Access Compliance Report Public Rights-of-Way (Curb Ramps)

Main Street: TIFFANY_PL Cross Street: WOODLAWN_AVE Location: N

ADA ID: RPRK220107123626 Ramp Type: Type 1 - Perpendicular Diagonal Initial Pass/Fail: Pass Overall Compliance: No Severity Score: 0

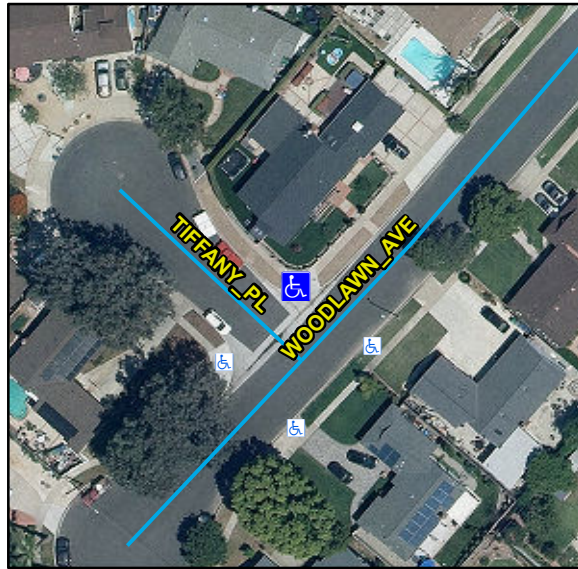
Compliance	Description	Data	Compliance	Description	Data
N/A	Ramp Length (in)	76	N/A	Flare Type LT	
Yes	Ramp Width (in)	48			Sloped
Yes	Ramp Run Slope (%)	7.9	N/A	Flare Slope LT (%)	5.5
Yes	Ramp Cross Slope (%)	0.2	N/A	Flare Traversable LT	No
N/A	Landing Present	Yes	N/A	Flare Type RT	
N/A	Landing Length (in)	48			Sloped
Yes	Landing Width (in)	48	N/A	Flare Slope RT (%)	3.3
Yes	Landing Run Slope (%)	0.5	N/A	Flare Traversable RT	No
Yes	Landing Cross Slope (%)	0	Yes	DWS Provided	Yes
N/A	Landing Movement Obstructed?	Yes	Yes	DWS Contrast	Yes
	Landing Movement Type	Curb	Yes	DWS Length (in)	36
N/A	Landing Shared	No	Yes	DWS Full Width	Yes
N/A	Clear Space	Yes	Yes	DWS Offset Left (in)	0
N/A	Clear Space To Crosswalk (in)	48	Yes	DWS Offset Right (in)	N/A
N/A	Marked Crosswalk 1	No	N/A	Marked Crosswalk 2	No
	Crossing 1 Direction	SW		Crossing 2 Direction	SE
	Marked Crosswalk 1 Width (in)	N/A		Marked Crosswalk 2 Width (in)	N/A

Remove & Replace Landing.

R304.2.1, STD 1115
